**AGENDA
PLANNING & ZONING COMMISSION
CITY OF LEANDER, TEXAS**

August 25, 2022 at 7:00 PM

8. Disapproval of Subdivision Case 22-SFP-009 to approve the Moon Valley Short Form Final Plat on two parcels of land approximately 8.8 acres $\pm$ in size, more particularly described by Williamson Central Appraisal District Parcels R031223 and R319362; more commonly known as 15841 Ronald Reagan Blvd, Leander, Williamson County, Texas.

The above referenced short form final plat application has been reviewed for conformance with applicable City ordinances and generally accepted engineering practices. The following are City staff comments. If you have any questions, please contact the individual reviewer directly.

2. SHEET 1 – COVER SHEET

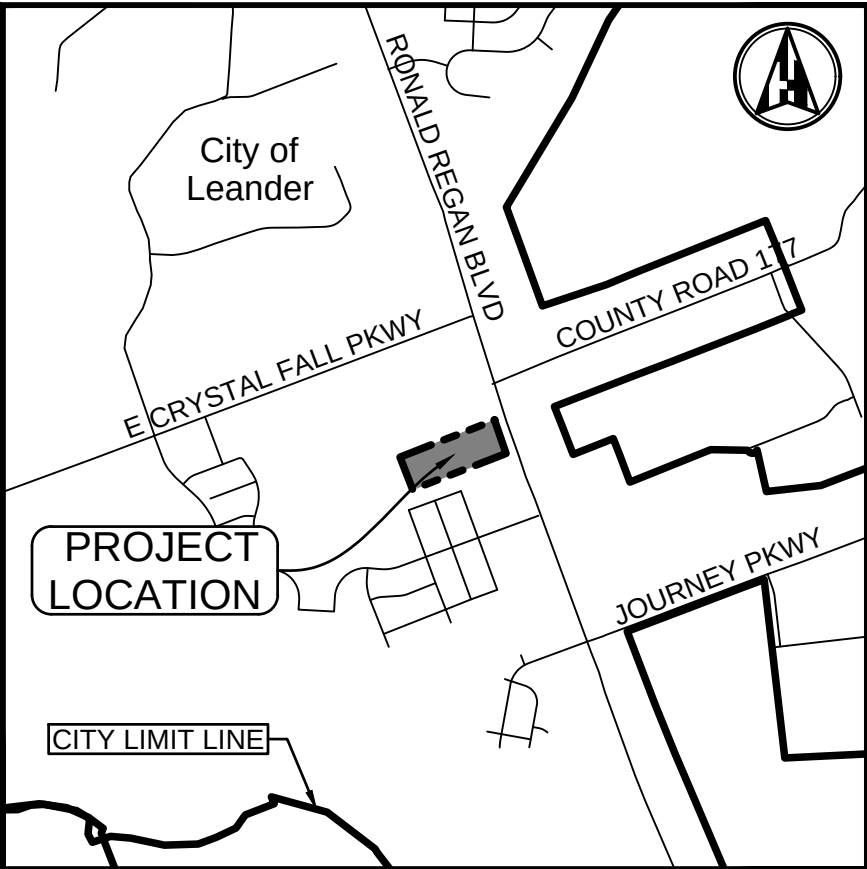
- i. Update the submittal date to state Filing Date. These plans were filed on 07/26/2022. (SO Art II, Sec 24 (c)(1)(ii))
- ii. Revise title to read as below (SO Art II, Sec 24 (c)(1)(i)):
Subdivision Name
Short Form Final Plat
- iii. Is the ownership correct? The application had a different owner listed.

SHEET 02 OF 03

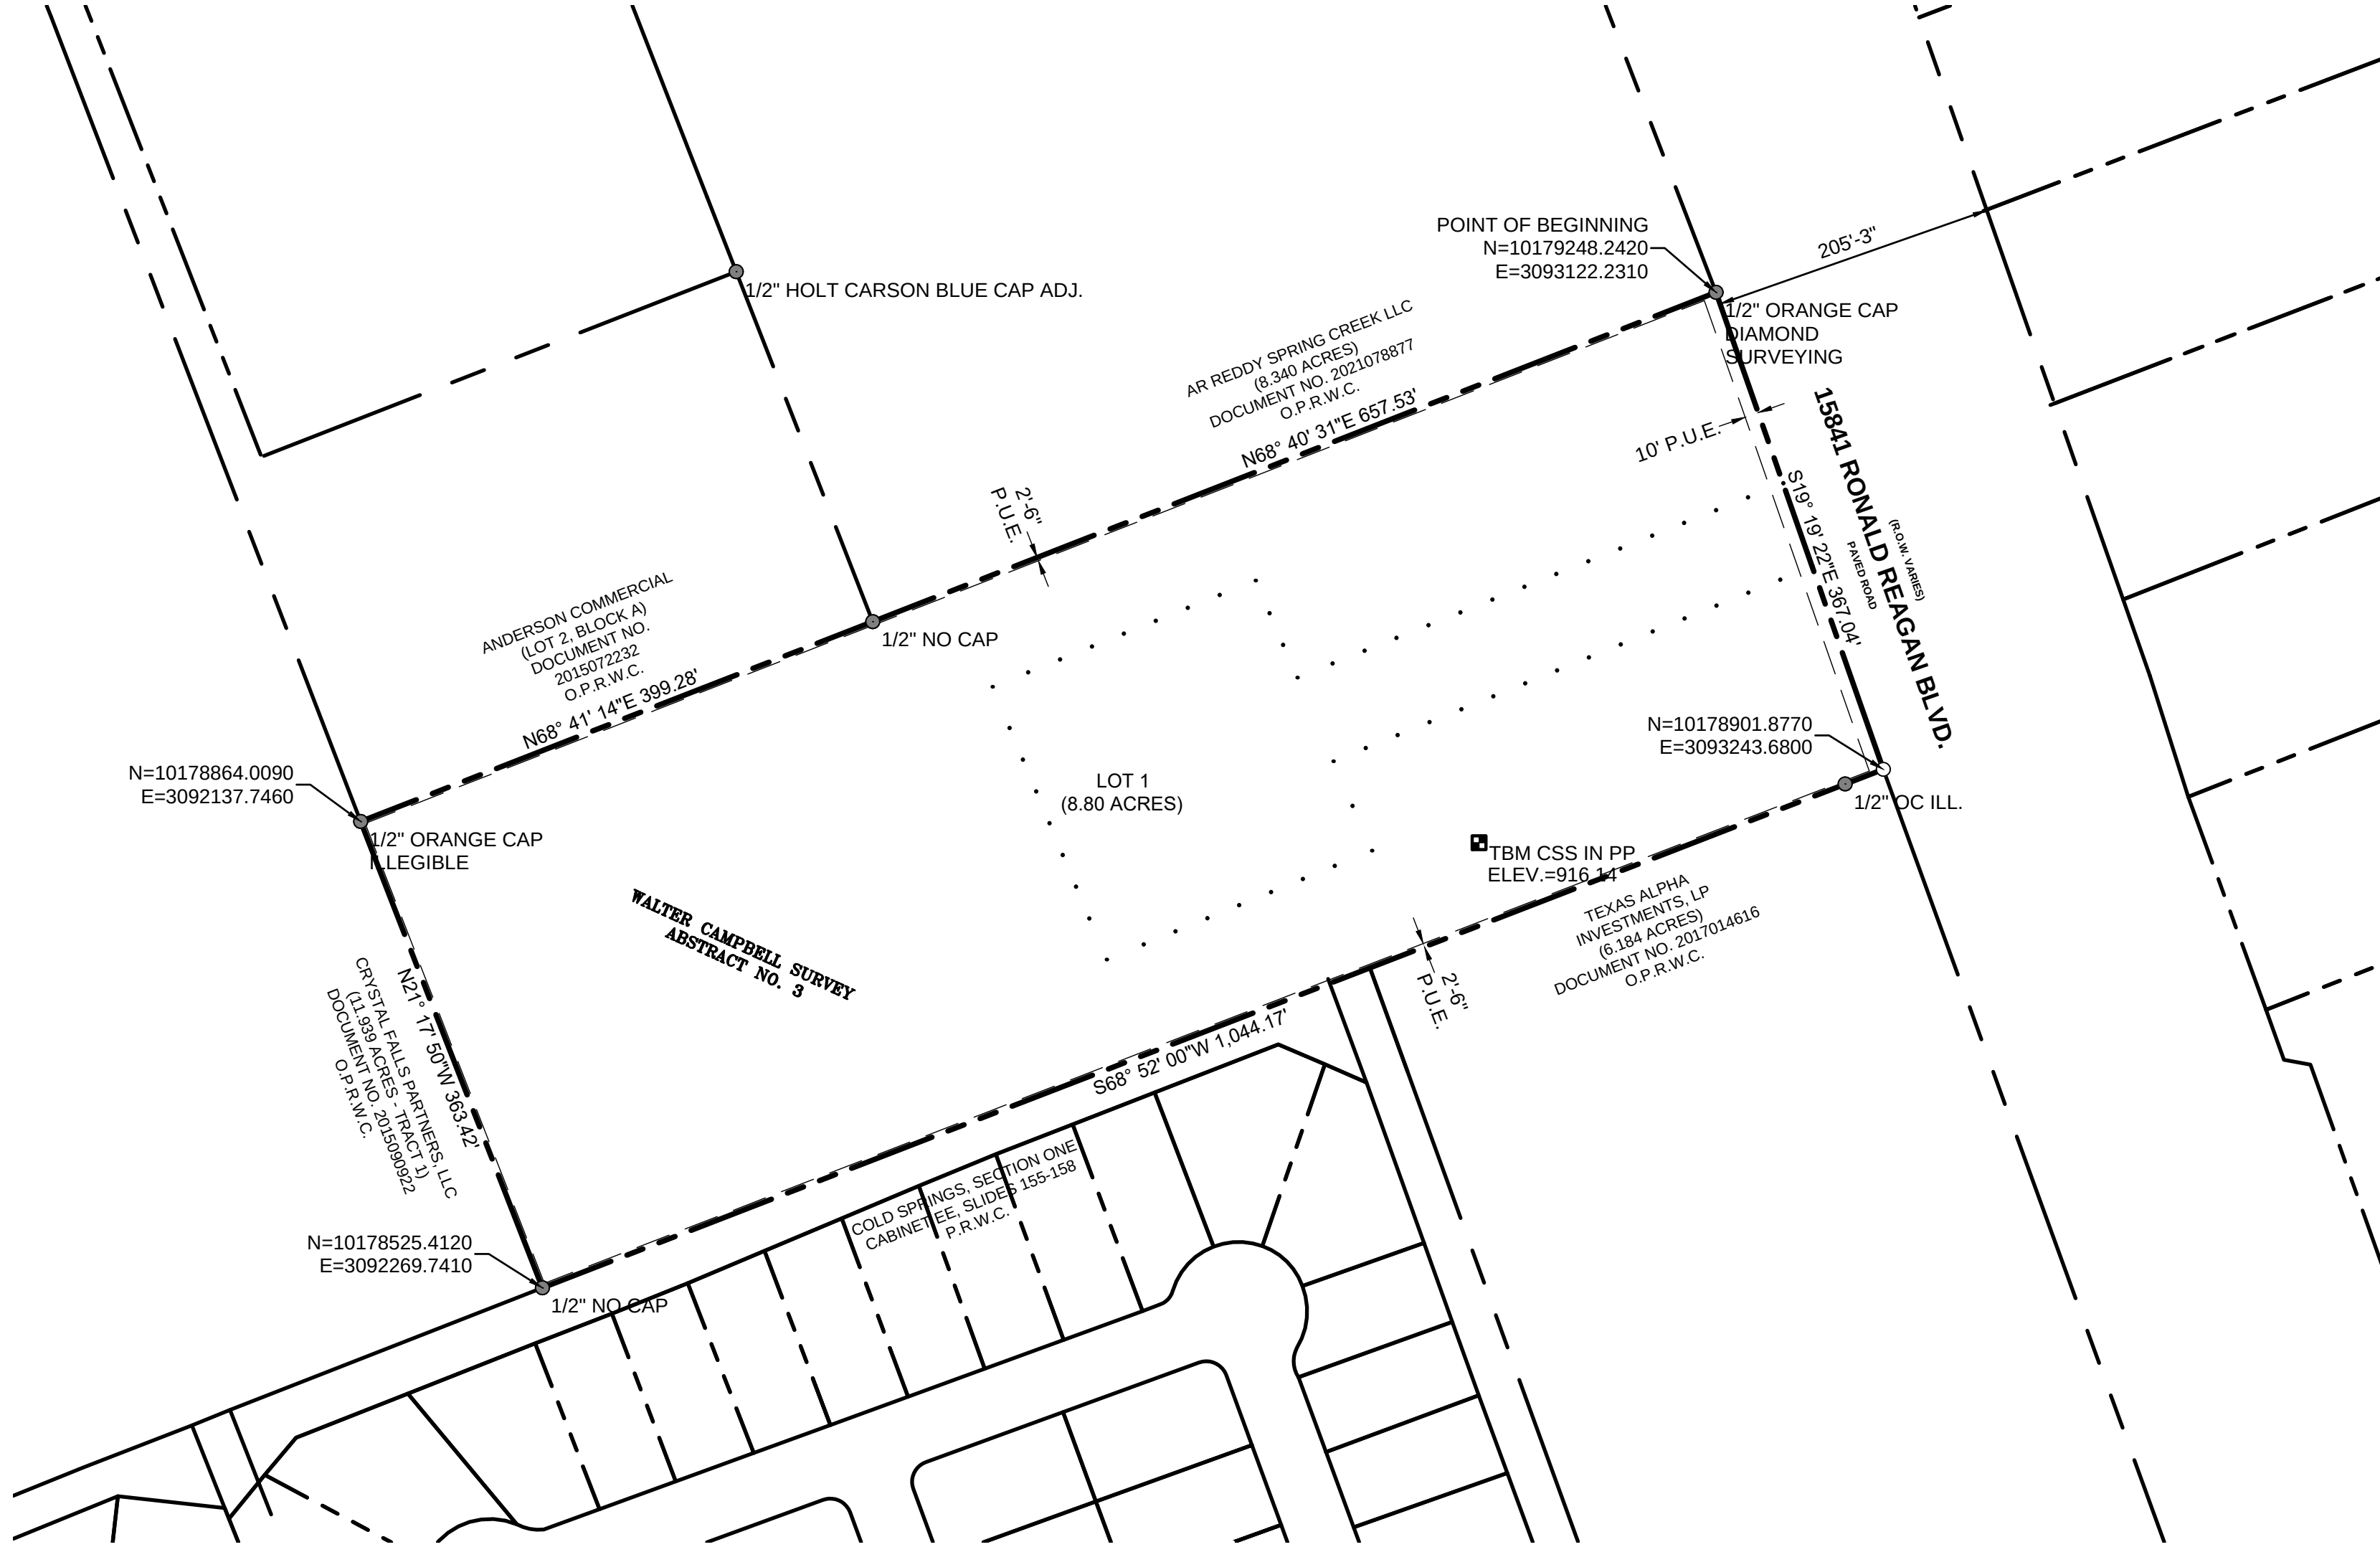
- i. Revise property lines to be a solid, heavy, and black line. (SO Art II, Sec 24 (d)(2))
 - ii. Revise the 10' PUE along Ronald Reagan to be a 10' public utility, landscape and pedestrian access easement (SO Art III, Sec 46 (c))

- iii. Graphically show the proposed location of sidewalks along Ronald Reagan and provide width as 10'. (SO Art II, Sec 24 (c)(4)(vii))
 - iv. Identify any ROW to be dedicated along Ronald Reagan based on the Transportation Master Plan. (SO Art III, Sec 42 (b)(2)(vi))

- v. What does the dotted line in the center of the lot represent?
4. SHEET 3 PLAT NOTES
- i. Provide the Metes and Bounds description (SO Art II, Sec 24 (c)(3)(iv))

- a. 2.5' PUE along the back property line.
- b. Add the various line types to the legend.
- c. What is the dotted line shown below? Add the line type to the legend.

- d. Provide survey ties at no less than three hundred (300) foot intervals across boundary streets indicating existing ROW width/location.
 - e. Provide metes and bounds description.
3. Sheet 3 – NOTES & SIGNATURES
- a. Provide all signatures with the final submittal.
 - b. Fix note 8 to specify if any portion of the subdivision lies within the floodplain.
 - c. Fill in Note 10 street names.

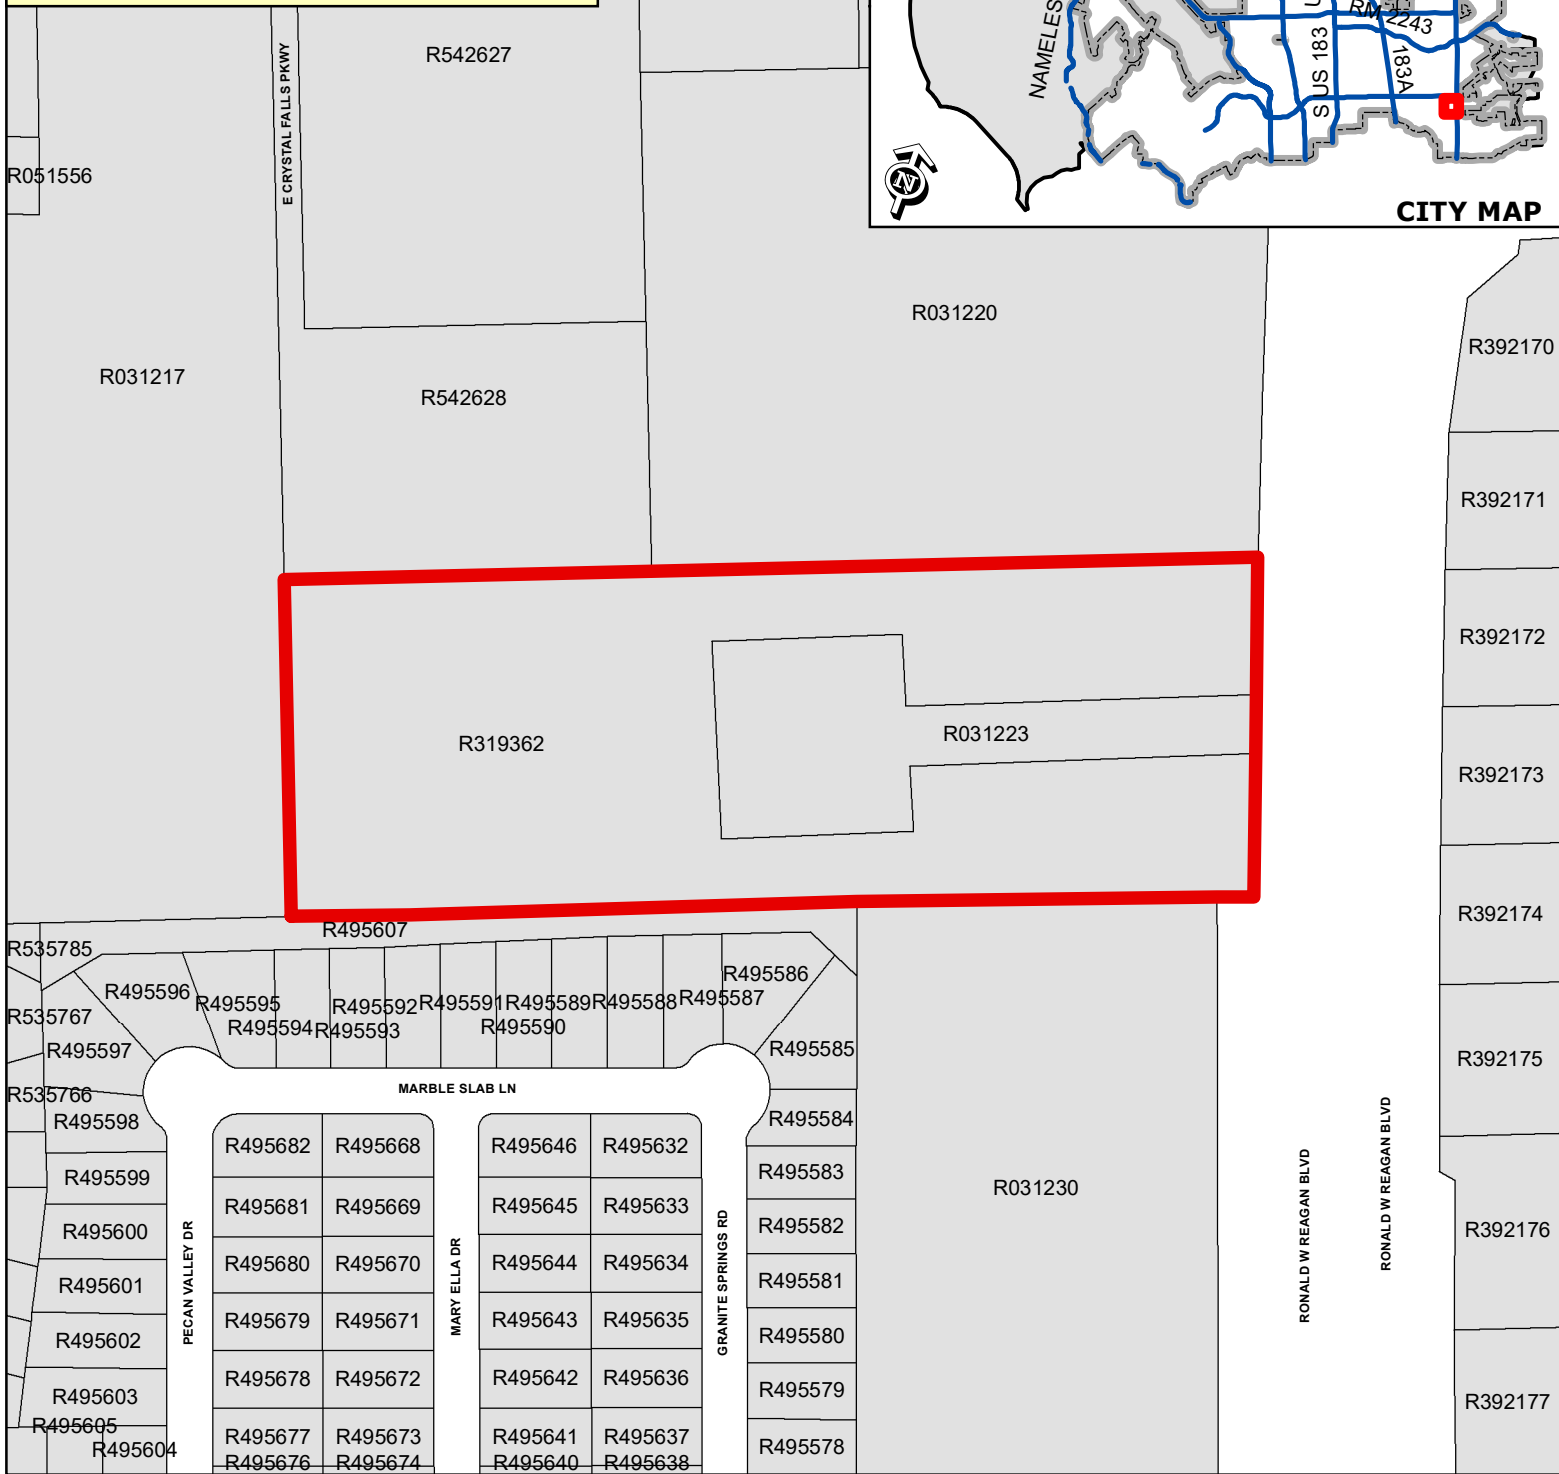
- ii. Update the surveyor's statement to reference the title commitment and dated within one year (SO Art II, Sec 24 (c)(1)(ii) & (iv)).
 - iii. Provide the title of the authorized signing officer for the owner signature block. Ensure the subdivision name matches the Cover Sheet if the name is changed. (SO Art II, Sec 24 (c)(1)(vi))

- iv. Revise note 7 to refer to the 10' public utility, pedestrian access and landscape easement along the ROW. (SO Art III, Sec 46 (c))
 - v. Complete all blanks in note 10. (SO Art II, Sec 24 (c)(6)(vii))

- vi. Update the notes to comply with the application and checklist. For example, note 8 should be edited to remove the references to residential garages.
